Review of the Visual Impact Assessment Bulletin

The Bulletin

Figure 1 - Preliminary Screening Tool Part 1 indicating potential visual impacts for further detailed consideration

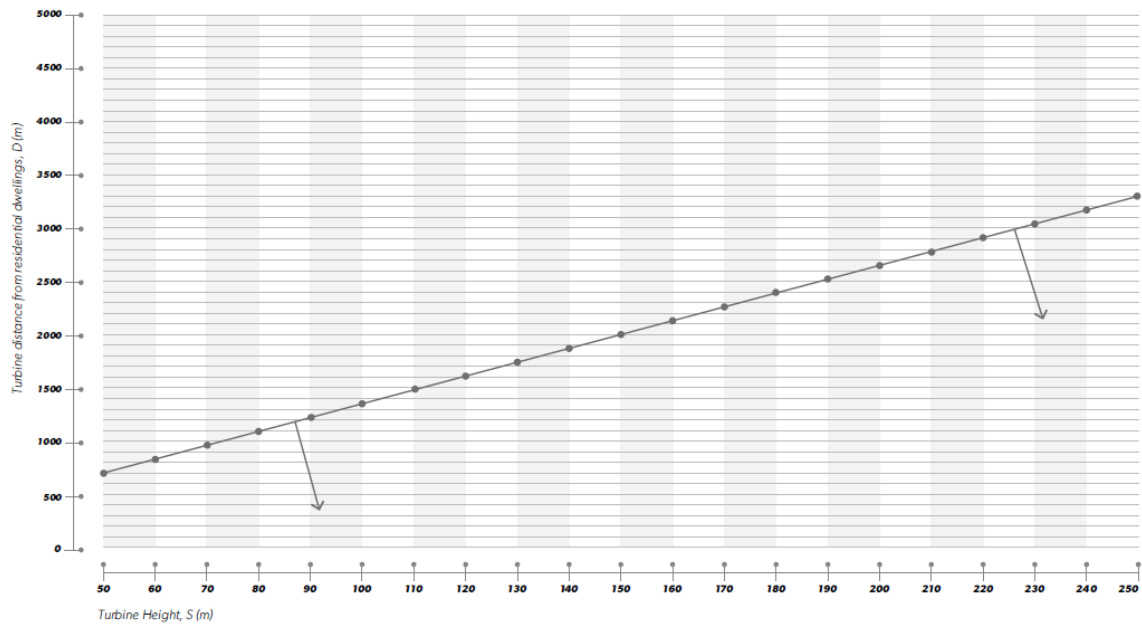
It would be hard to argue with the concept of Preliminary screening tool 1.¹² Height is influential, distance more so, but:

- The developers will argue that the line must be much lower.
- Conversely, every local community will be able to show you real examples of why the line should be much higher (see later).
- Should it be a line or a curve? Is the slope correct? Should it be a line or a range?

The scales suggest a degree of precision that may not be supportable.

Of course, you will be asked to justify and support, with referenced research, your choices by both sides. Can you?

At the time of writing, the residence is 2549 metres from the nearest planned turbine. For turbines 170 metres tall as proposed, that is above the line on screening tool 1. There are no other wind farms visible. Woodlawn is on the other side of the range over 6 kms away, so screening tool 2 is not in play. So the first issue is that you won’t hear about this residence at PEA time as developers don’t volunteer information that is not requested.

Figure 2: Preliminary Screening Tool Part 2 indicating multiple wind turbines

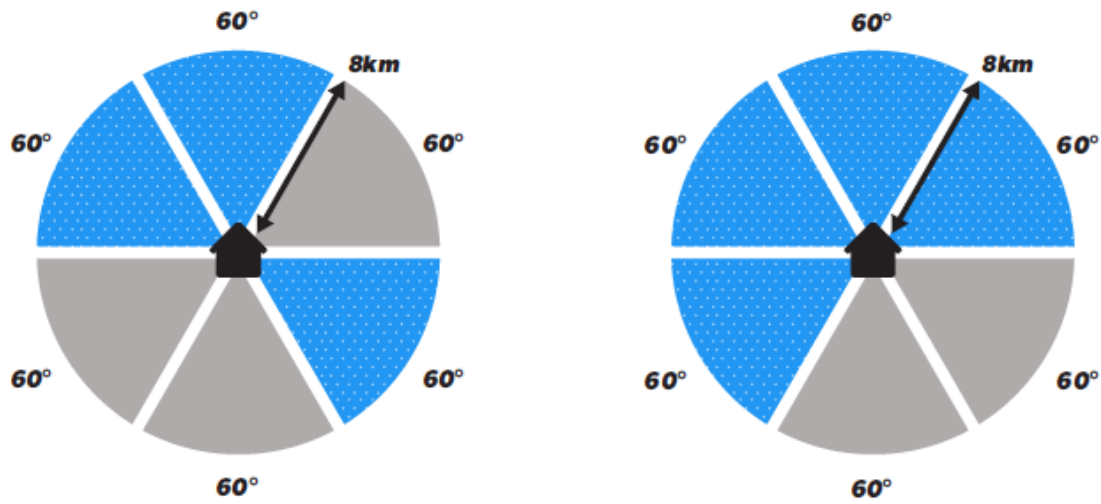
The Multiple Wind Turbine Tool (Preliminary Screening Tool 2) will also highlight to prospective developers the suitability or otherwise of their planned wind farm. We have argued previously that the definition of cumulative impact should be as proposed in the Bulletin and apply intra-wind farm. (The proposed Jupiter wind farm is, in effect 3 wind farms, with some clusters further away from each other as Woodlawn is from Capital)

A badly sited wind farm, of course, will “fail” under both preliminary screening tools, with many residences suffering a severe Visual Impact due to distance and horizontal extent, but if some Spanish property developer is paying your salary, why would you give up. The Department can't stop you at any stage.

Unfortunately, when it comes to Visual Impact Assessment in Stage 2, the impact implied in screening tool 2 gets watered down (Page 27). All the developer has to do is to “provide detailed justification” (undefined).
